GEOLOGICAL SURVEY

Geologic Factors Pertinent To The Proposed A. J. Wiley Hydroelectric Project, No. 2845, Bliss, Idaho

Open-File Report 81-569

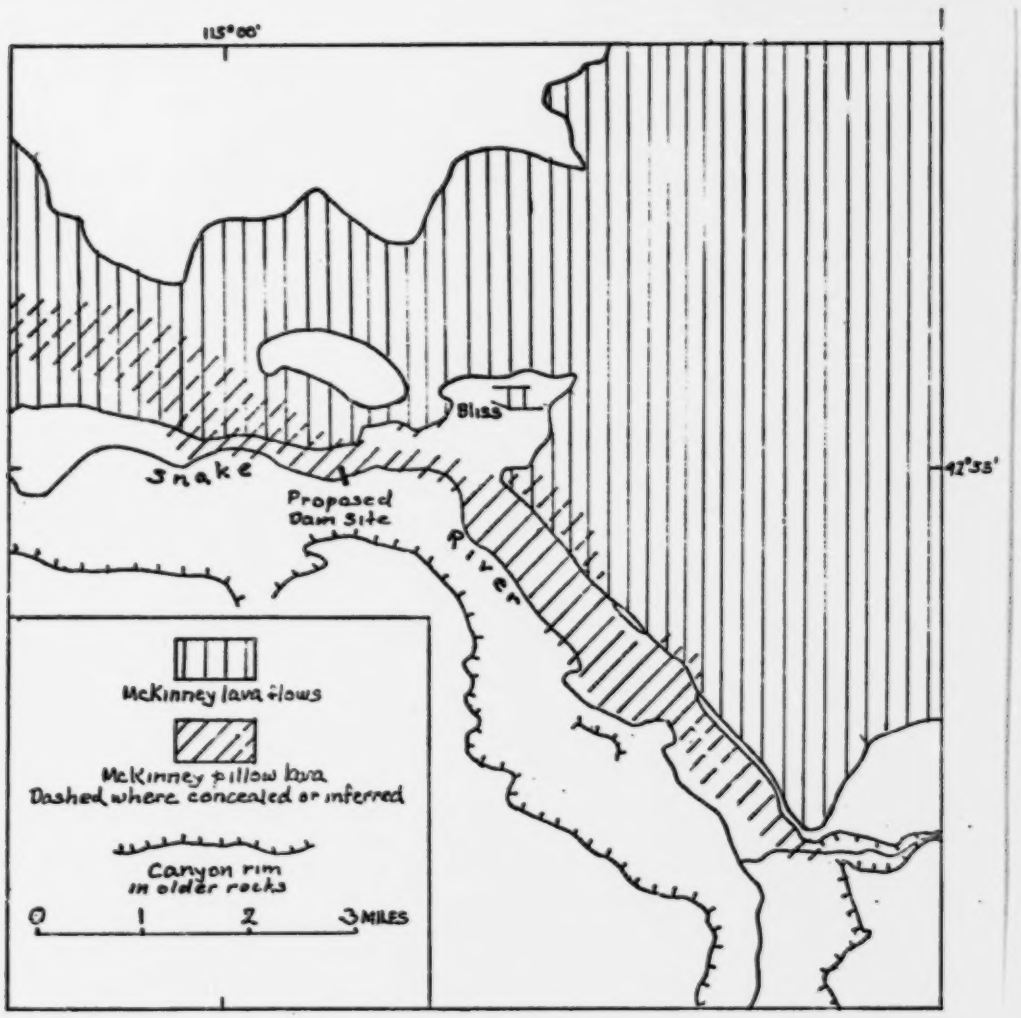
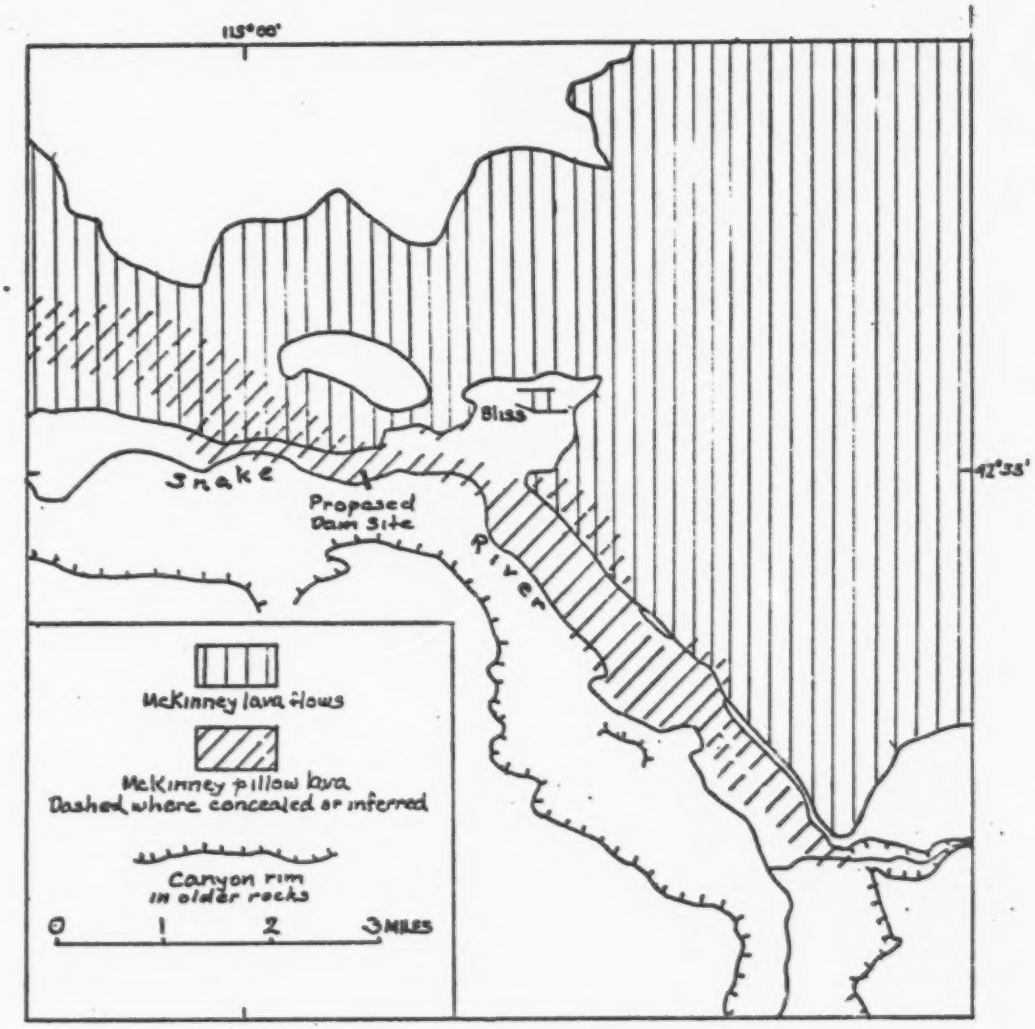
The McKinney Basalt in the area of the proposed project occurs as two facies: upland lava flows that form the canyon rim, and pillow lava that fills part of the ancestral canyon (fig. 6). The facies coincide in the sense that the pillow lava is found only where McKinney lava flows are present along the canyon rim. Both facies are largely confined to the right side of the canyon. The McKinney lava flows, like other late Pleistocene lava flows in the area, are comparatively resistant to erosion, and their distribution is pertinent when considering the hazard of landsliding at Bliss (Part 6.1). The pillow lava, on the other hand, is a highly porous material whose distribution is important to the problem of reservoir leakage (Part 4).

From outcrops of older rocks in the project area, it is clear that the ancestral McKinney canyon was approximately the size of the present canyon, although deeper, and was nearly in the same location. The left side as far downstream as the place where the ancestral canyon disappears into the northern wall of the present canyon, from 2 to 3 miles west of Bliss, was composed of Banbury Basalt and the overlying Glenns Ferry Formation. Some sinuosity is suggested by a projecting spur, capped by a remnant of Madson Basalt (NE1/4 sec. 29, T. 6 S., R. 13 E., Bliss quad.), and by adjacent embayments that preserve remnants of Root Lake clay. The right side of the former canyon in the project area was mostly outlined by a rim of Madson Basalt. The continuity of the Madson may have been interrupted in the landslide area at Bliss, although tangible evidence for this conjecture has not been found. Also, the Madson may be missing along a short stretch extending from 1 to 2 miles southeast of Bliss, which is covered by McKinney lava flows. It is unlikely that this gap in the Madson (if it exists) represents part of a former canyon of the Snake River around the east and north sides of Bliss. Such a canyon is physiographically improbable, and it does not account for the canyon-filling McKinney pillow lava found at the proposed dam site and from there downstream. Finally, the eastern canyon rim in the upper reach of the project area was formed by the Malad Member of

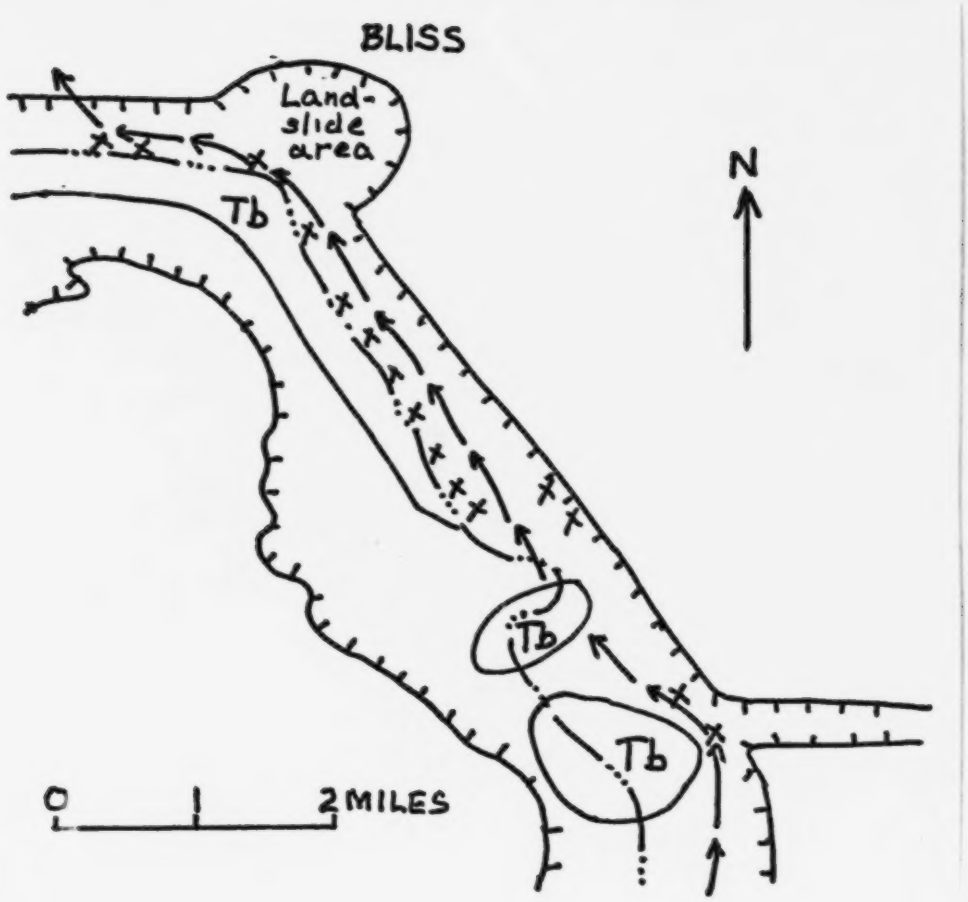
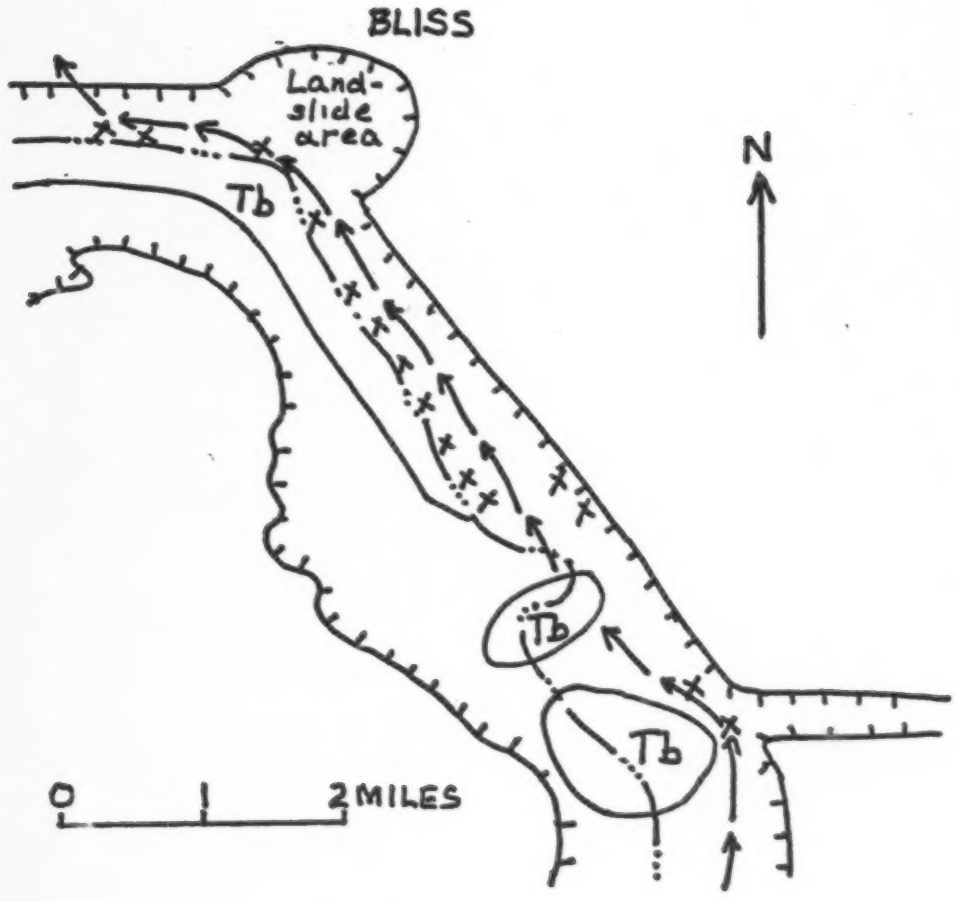
From the proposed dam site to the Bliss landslide, McKinney pillow lava is continuously exposed except for a covered interval from 0.3 to 0.7 of a mile above the dam. The covered interval is at the foot of a segment of the canyon wall that closely corresponds with the right wall of the former canyon, judging from a remnant of Madson Basalt below the canyon rim. Because Banbury Basalt along the left wall is exposed 500 feet south of the river, the floor of the former canyon must lie approximately beneath the river. The depth of the former canyon in the right abutment of the proposed dam (altitude 2,550 feet) indicates that the canyon floor can be expected to be about 100 feet below the

river at this place, covered by a substantial thickness of pillow lava. Drilling to test this inference would be desirable because of the connection that might be thereby confirmed with pillow lava farther upstream. Such a connection would augment the length of the reservoir where water could be carried to the right abutment via the concealed canyon fill of pillow lava. Also, if such a connection is confirmed, the task of installing an impervious blanket to prevent leakage from the proposed reservoir into the pillow lava--assuming that no other remedy is more practial--would be greatly increased. The length to be sealed would reach at least a mile upstream, and an undetermined amount of river gravel might have to be removed from the reservoir floor before a sealant could be effectively applied.

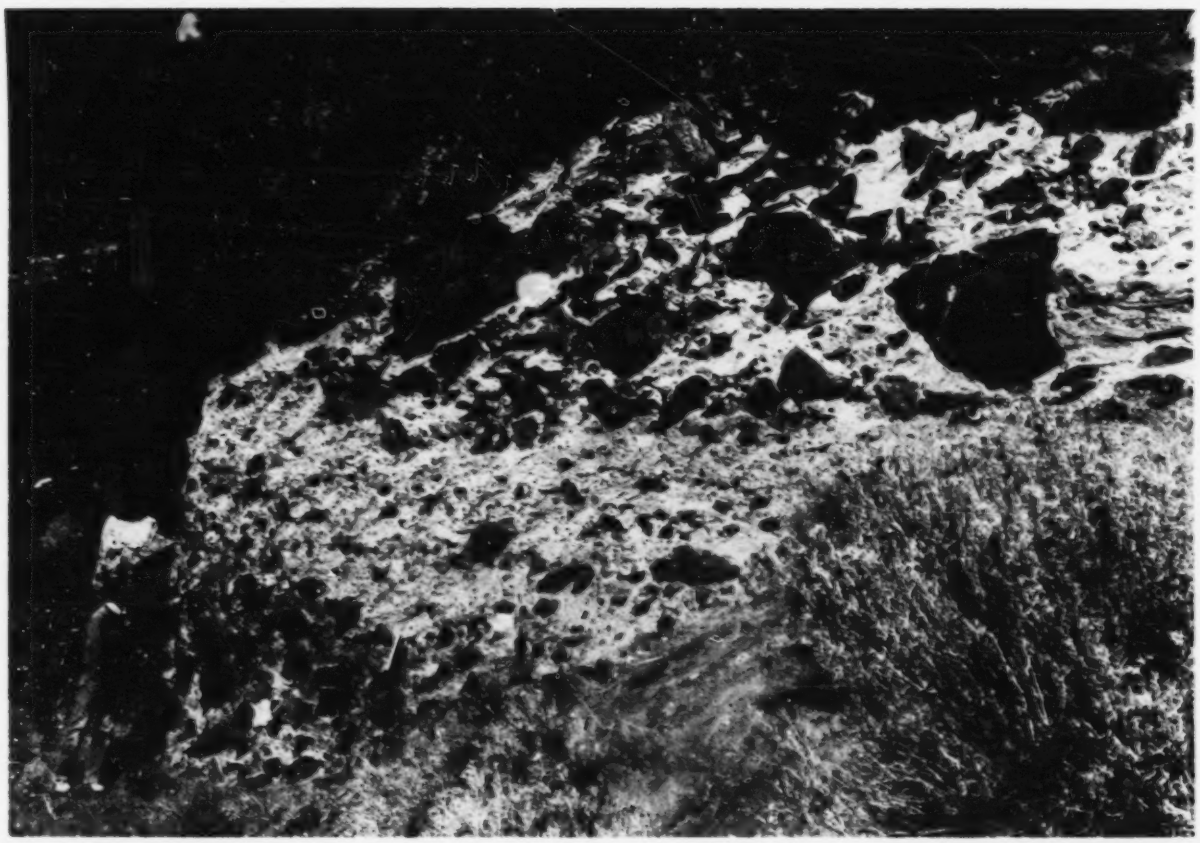
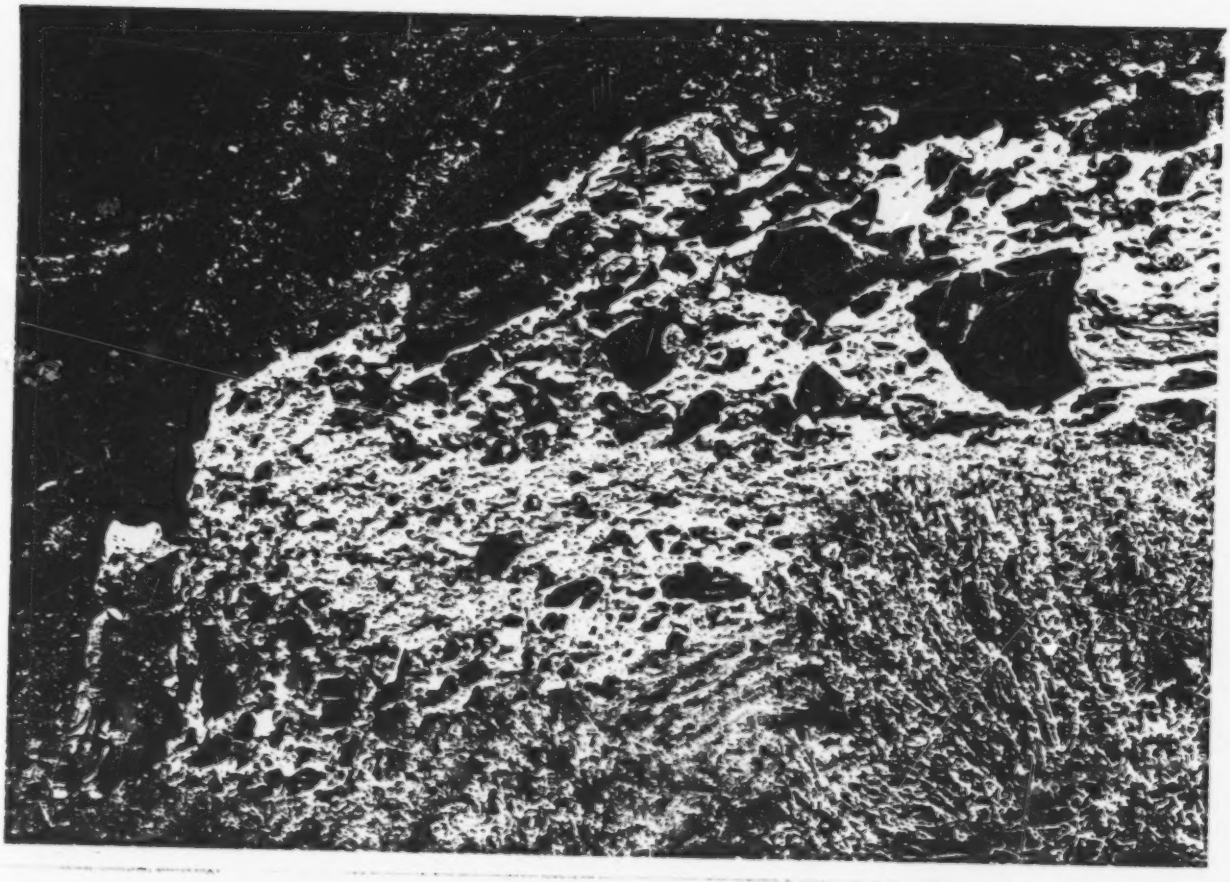
As shown in figure 10, a conspicuous feature of most of the debris is mixed sizes of basaltic blocks surrounded by a matrix of light-colored clay, silt, and sand. The basalt pieces range in size from small pebbles to blocks several feet across. They are highly altered and resemble the lithology of Banbury Basalt in the area, although some of them may have been derived from a local lava flow in the Glenns Ferry Formation, which is also strongly altered. Many of the basalt pieces are angular, even to the extent that corners form acute angles. In contrast, the matrix is almost entirely fine grained, although small pebbles of clay and silt can be found that are undoubtedly coherent pieces derived from older sedimentary deposits, probably the Glenns Ferry Formation. A few such pieces are several feet across (fig. 11). Also, some parts of the debris consist of small fragments of sediment and basalt in approximately equal proportions (fig. 12). During the field conference, Jack Duckworth found that pieces of the matrix slake and fall apart when placed in water.

In figure 10, the debris can be roughly divided into three layers, although the contacts between layers are gradational. Neither layer can be said to be sorted, but some sorting into thinner intervals with contrasting textures can be discerned in the middle layer. These layers have very limited lateral extent. About 150 feet along the outcrop northwest of the area of figure 10, the same layers are no longer recognizable, and the debris has a very different appearance (fig. 12).

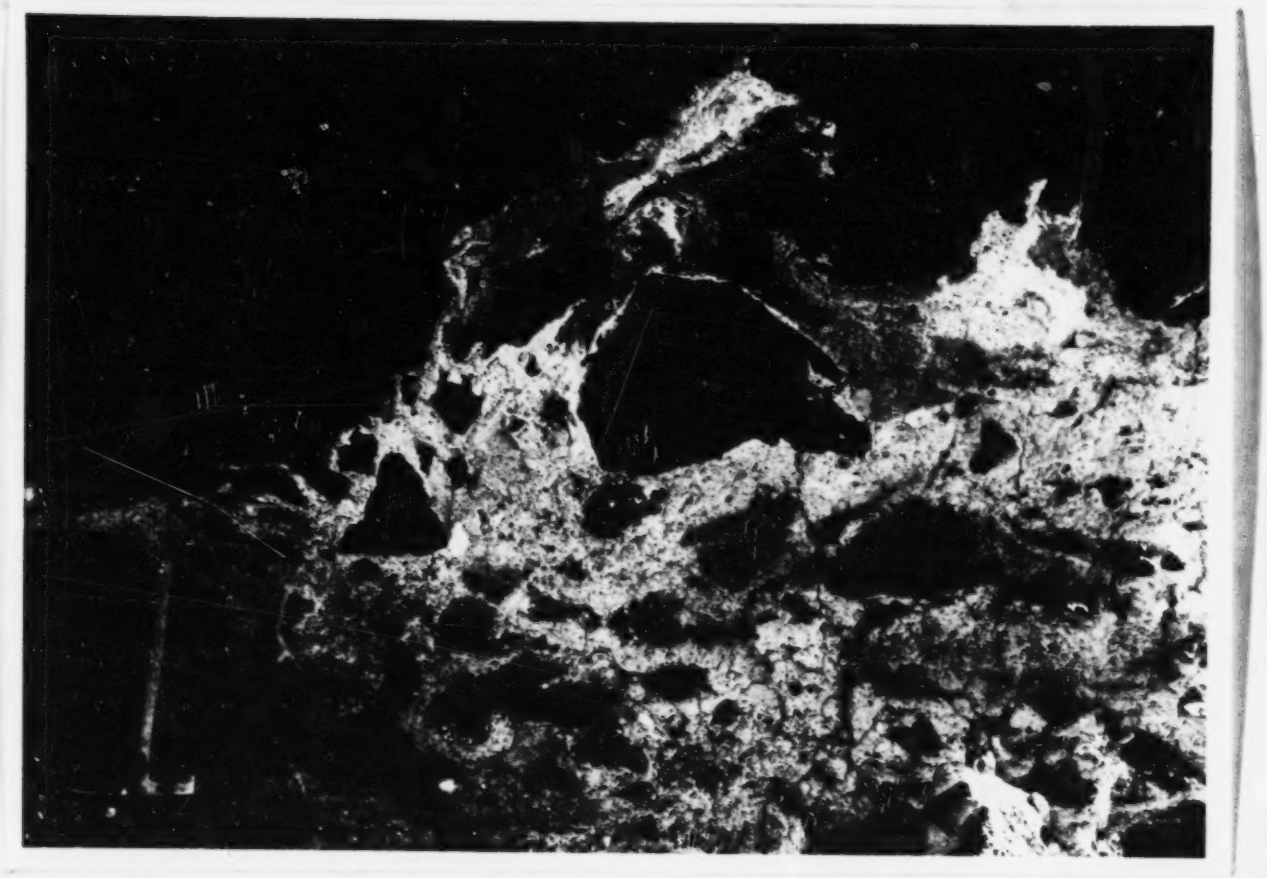
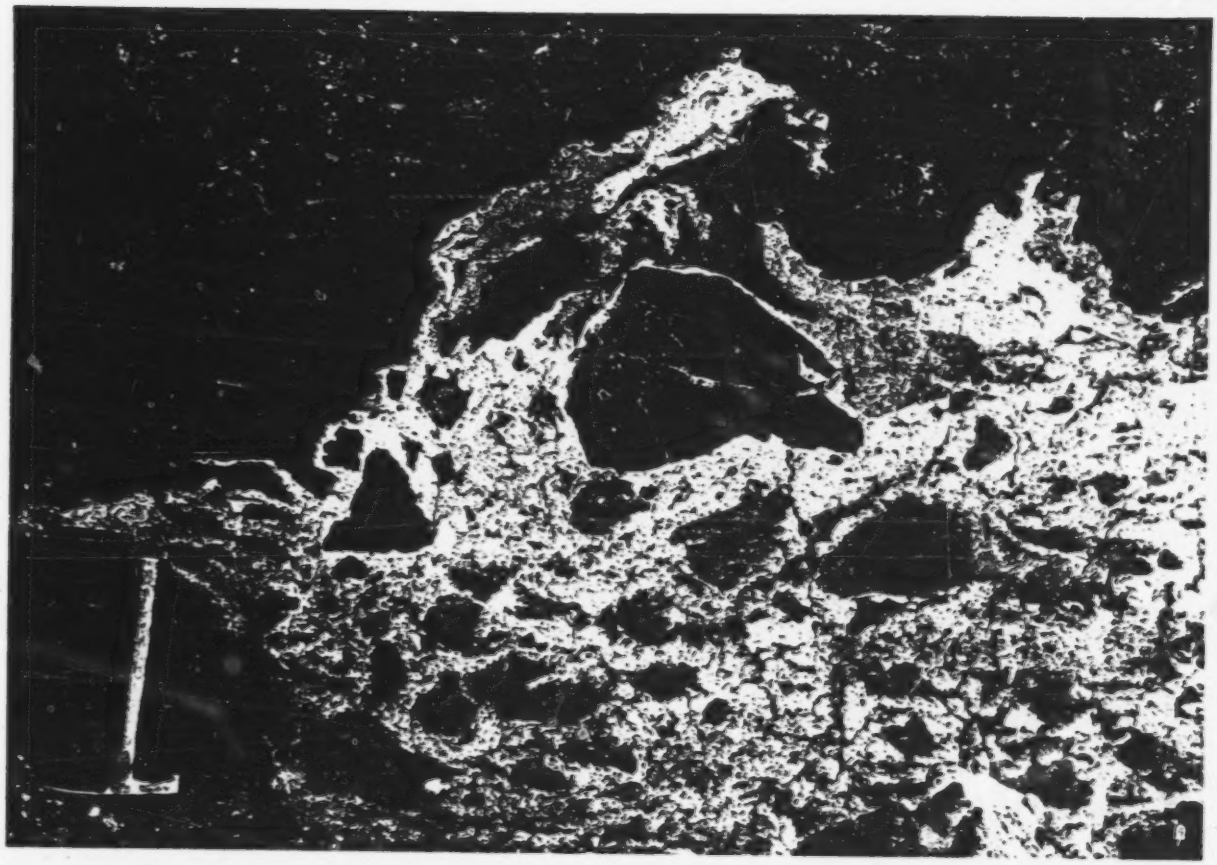
Together, the poor stratification and lack of sorting of the debris, its discontinuous lithology, and the acute angularity of its larger components support the concept that the debris was deposited as a viscous fluid. Such an origin is also indicated by the nature of the contact with the overlying McKinney pillow lava, which in places displays convolutions that are best attributed to a high degree of fluidity in the matrix of the debris (fig. 13).

The presence of the debris at the proposed dam site poses difficult problems in engineering (see Deficiency L/N-2). Its physical characteristics must be explored with the knowledge that significant lithologic changes can be expected in distances as short as a few feet. Its hydraulic conductivity will likely vary in accord with changes in the mixture of basaltic fragments and matrix, and in accord with gradational relations to McKinney pillow lava. Finally, the debris appears to be susceptible to a loss in strength when wet.

Plans by the applicant call for placement of "transition-drain filter material" directly on the debris (older alluvium) in the downstream part of the embankment section (zone 2 in fig. 9). In other words, the debris would be kept continuously wet by seepage through the drain material. The debris might thereby become saturated and lose its strength, thus causing failure of the dam. To evaluate the potential loss of strength in the debris, I am advised by R. W. Fleming of the U.S. Geological Survey, that

appropriate tests should be made to determine its behavior when wet. Based on these determinations, a stability analysis through the embankment would provide an estimate of predicted stability. For the intake and spillway sections, a similar analysis is needed, together with an evaluation of the potential for differential settling. Unequal subsidence could be caused by differences in consolidation characteristics of the debris and the pillow lava. Depending on the tests and the findings about the lithologic variability of the debris under the proposed structure, the wise course might be to completely excavate the debris from the area of the dam site.
